CITY COUNCIL AGENDA

**CITY COUNCIL
WORK SESSION STAFF REPORT
ITEM NO. 3**

TOPIC: Madinah Lakes PUD Concept Plan

CONCEPT PLAN 04/17/24

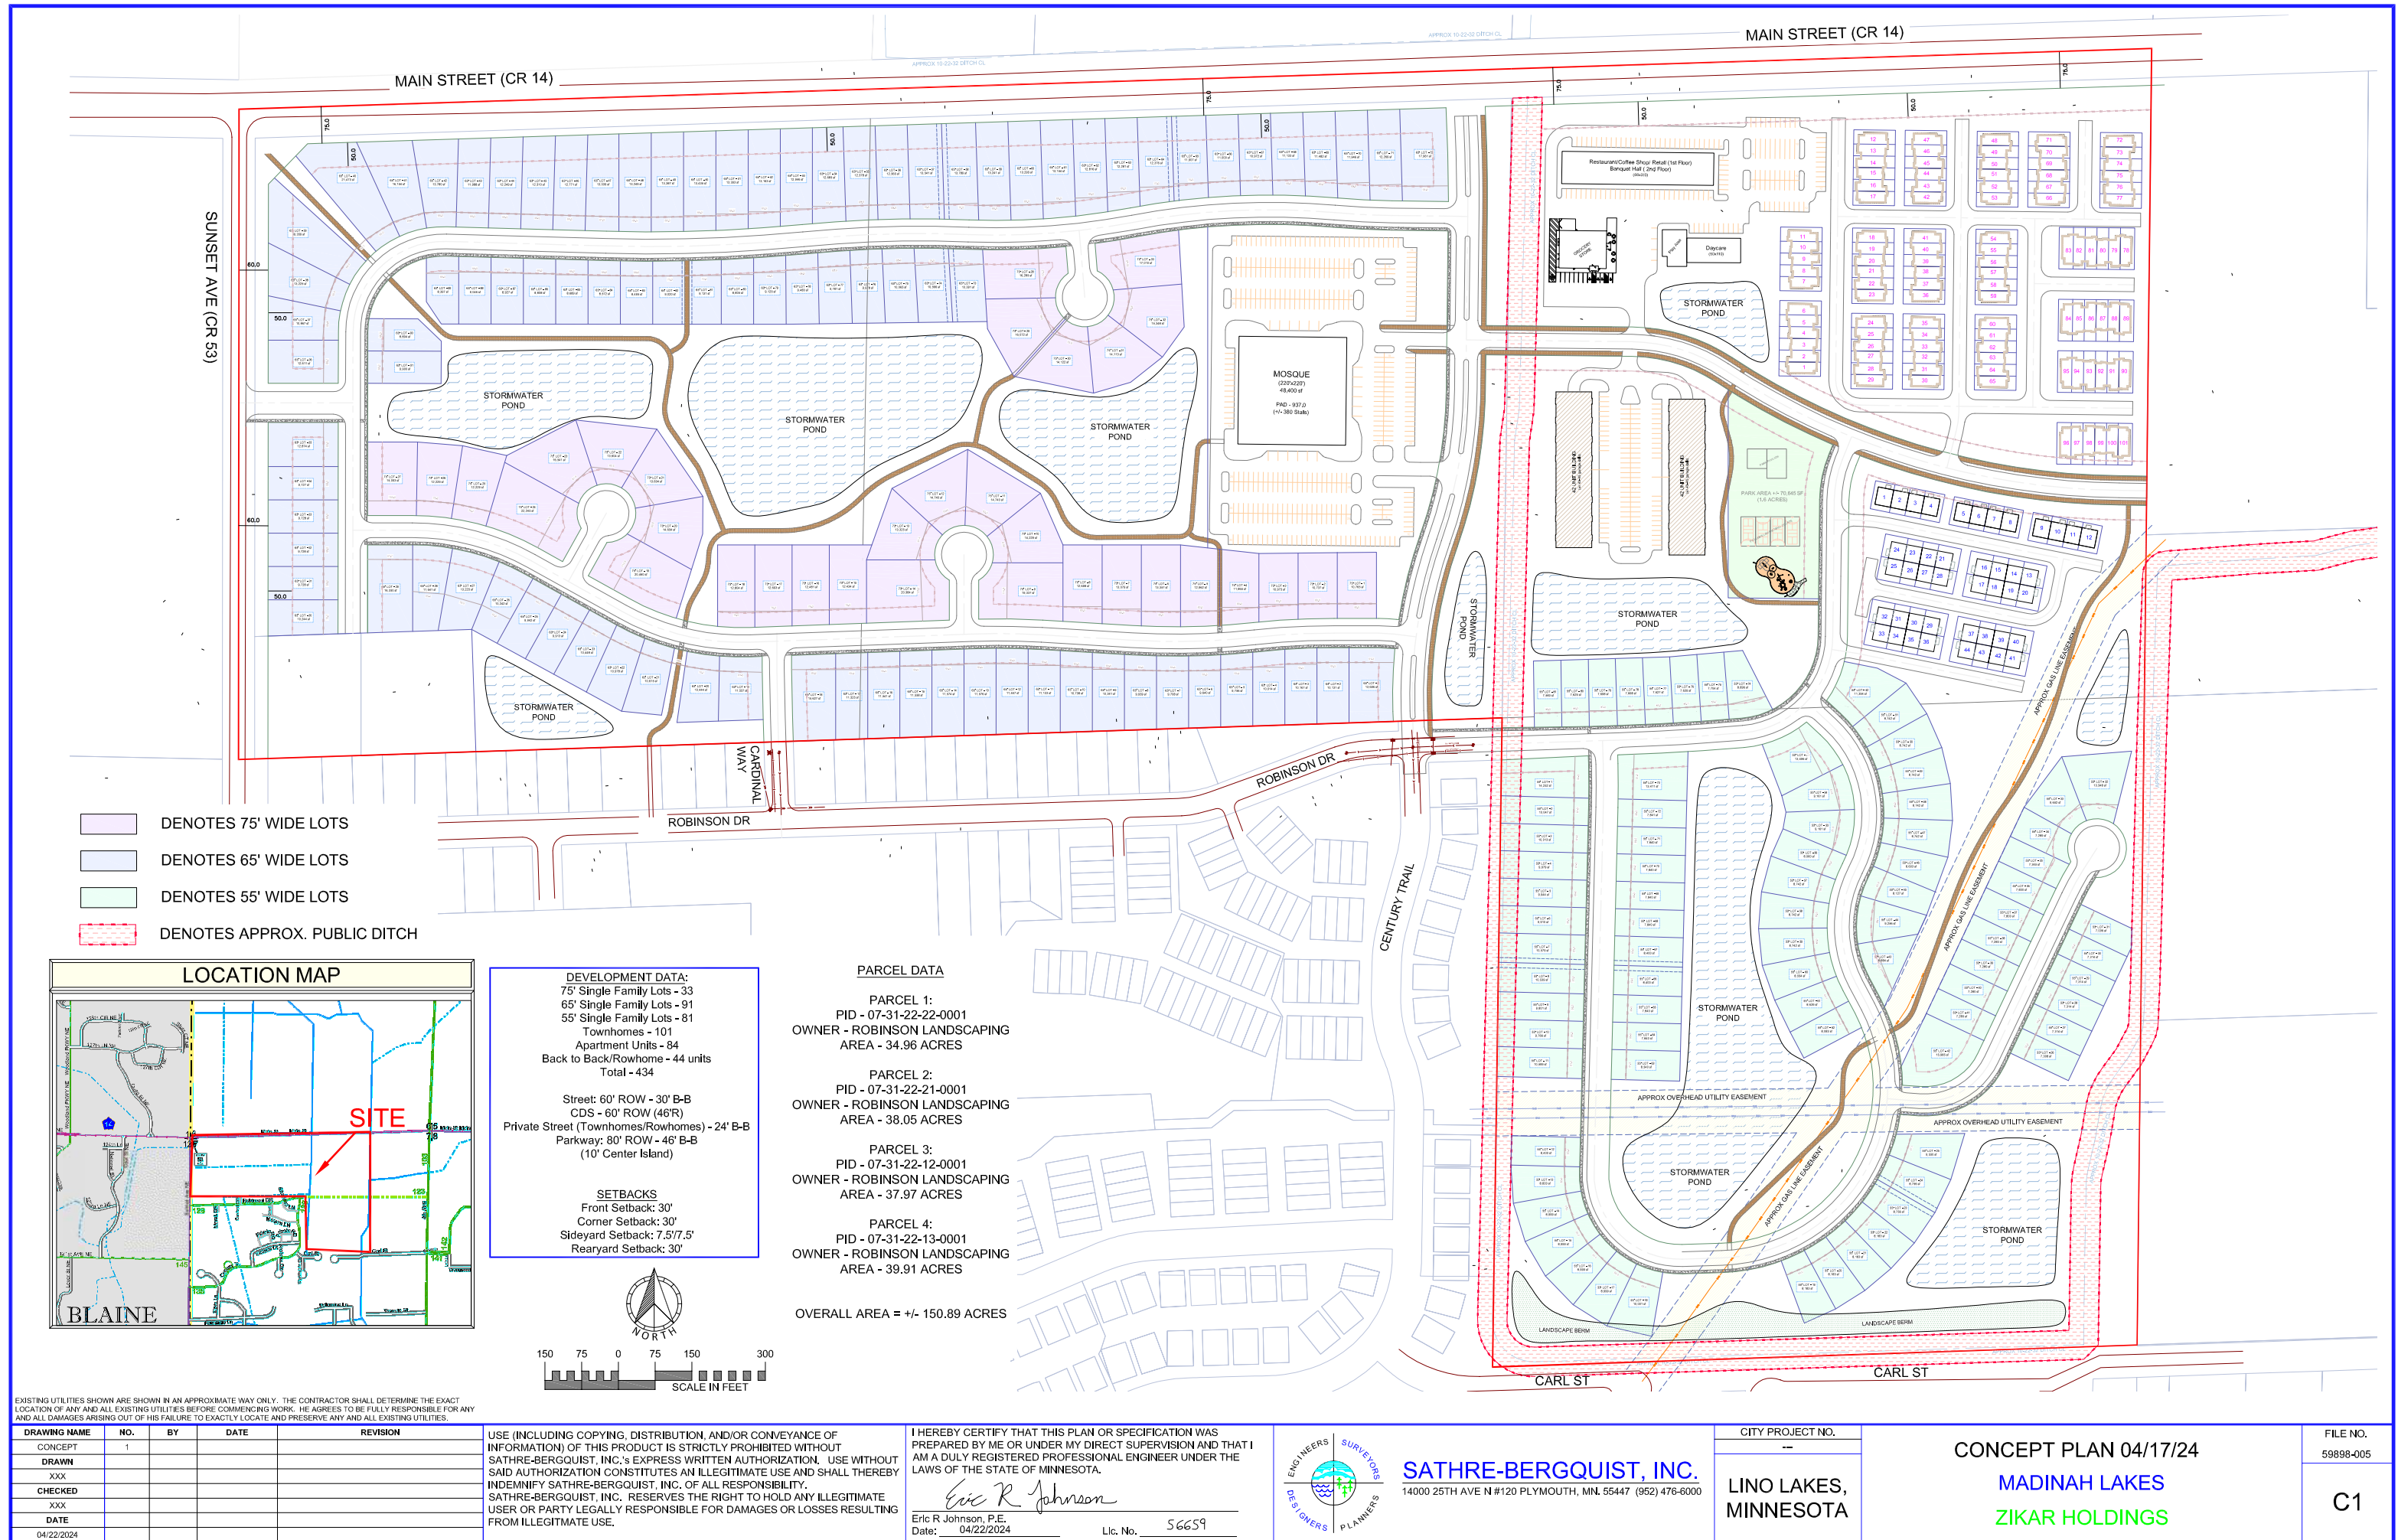
1. The applicant may need to provide additional public benefit in order to be considered for PUD zoning. Examples could be more open space, enhanced greenway corridor, wetland restoration, additional wetland buffers, higher architectural & building standards etc.

Staff recommends establishing minimum lot width and lot depth requirements for the single family homes. As discussed during the previous Promenade concept plan and implemented in Lennar's Watermark development, the following minimum lot sizes could be established:

Watermark also allowed for 120 ft lot depths on lots abutting open space. Per the attached Madinah Lakes concept plan, these lots could be those abutting larger storm water ponds if on wider greenways

1. City Code Section 1007.024(6) further details Urban Residential Planned Unit Development requirements in regards to municipal water and sanitary sewer services, density, open space, neighborhood performance standards and yards. The applicant shall demonstrate these requirements are met.
2. The townhome decks/patios cannot extend into street setback.
3. A minimum 50-foot wide buffer shall be provided in compliance with § 1007.049 on the single family and townhome lots abutting CSAH 14 (Main Street) and CR 53 (Sunset Ave).
4. A minimum 20-foot wide buffer shall be provided in compliance with § 1007.049 on the townhome lots abutting the street extending to the east lot line and on the single family lots abutting Carl Street.

- Applicant should have neighborhood meeting
- Shift the mosque closer to Main Street
- Provide public access to lake
- Mixed support for density
- Mixed support for lot widths and lot sizes
- Mixed support for proposed natural buffers in side yards

The applicant is proposing 55-65ft wide single family detached lots adjacent to existing 62ft wide single family lots in Century Farm North. Adjacent to the larger rural residential lots along Carl Street, 55ft wide lots are proposed; however, a landscaped berm and buffer provide separation from the varying land uses. Townhomes and apartments are proposed in the northeast section of the development near arterial and collector roads.

YIELD PLAN
MADINAH LAKES
ZIKAR HOLDINGS

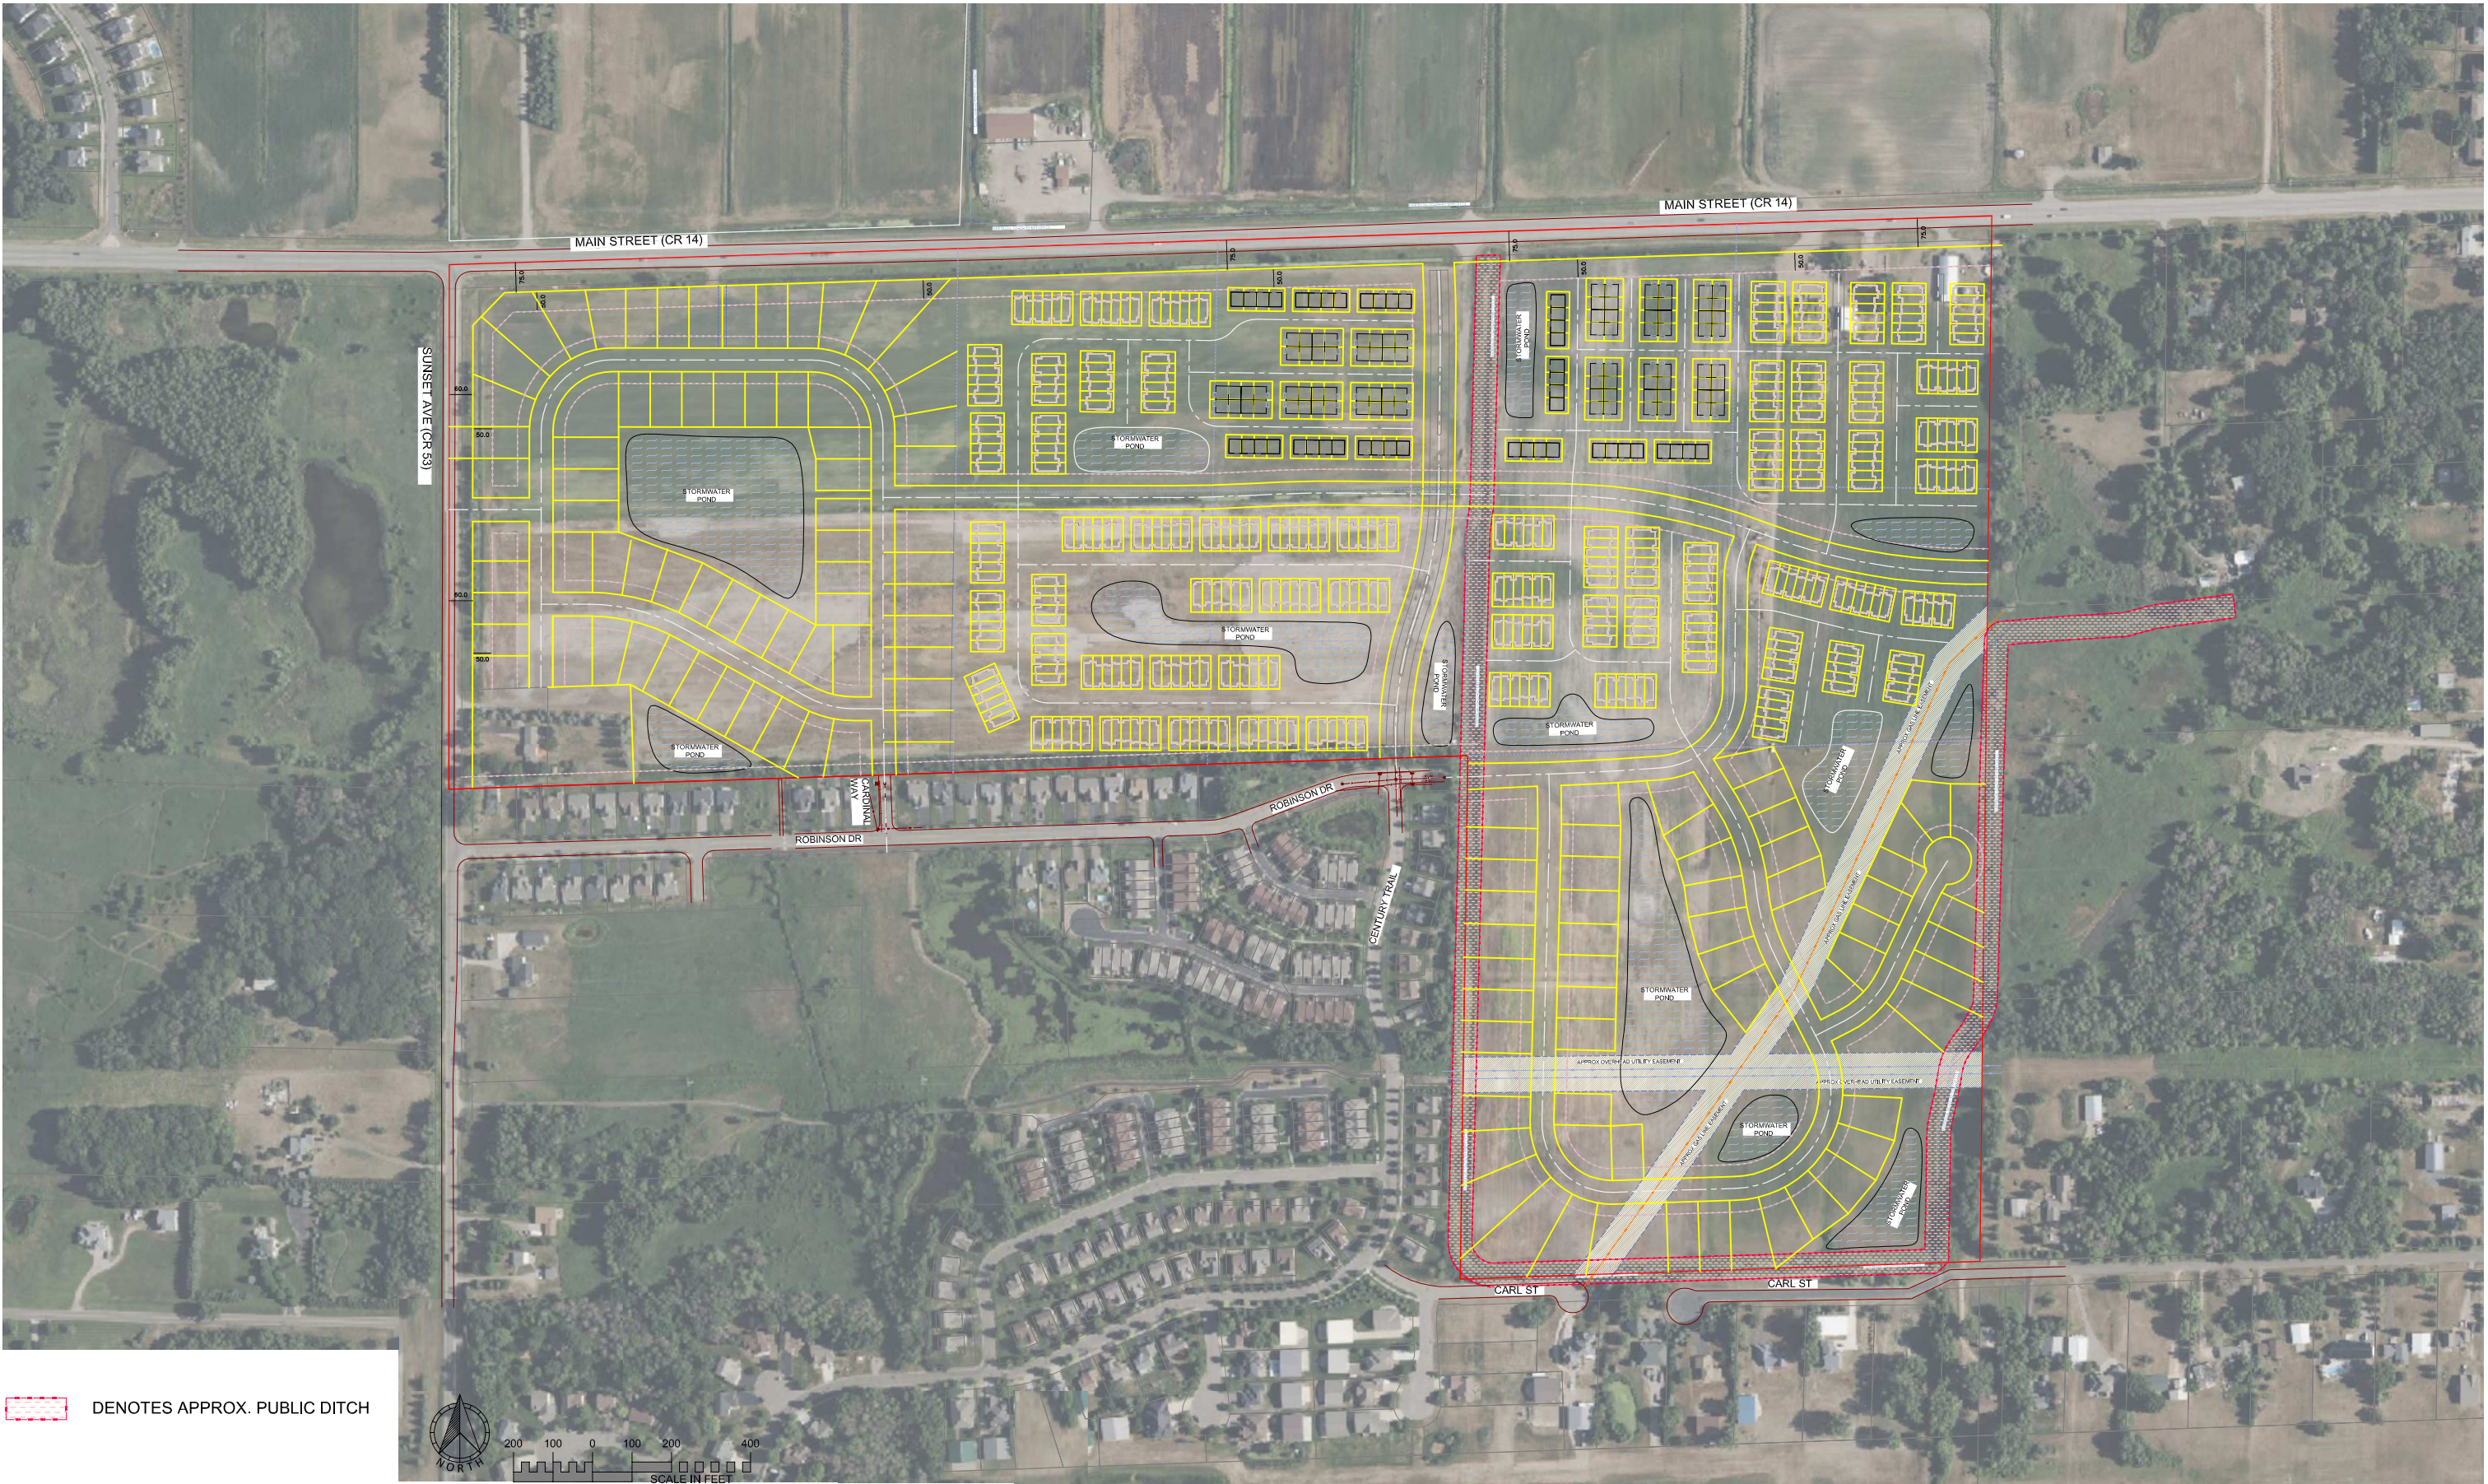
The submitted yield plan indicates 127 single family lots (80ft wide), 362 townhomes, and 132 rowhomes for a total of 621 housing units.

1. Under the Yield Plan Data chart, 84 apartment units are listed but the yield plan does not include apartments. The chart shall be revised.
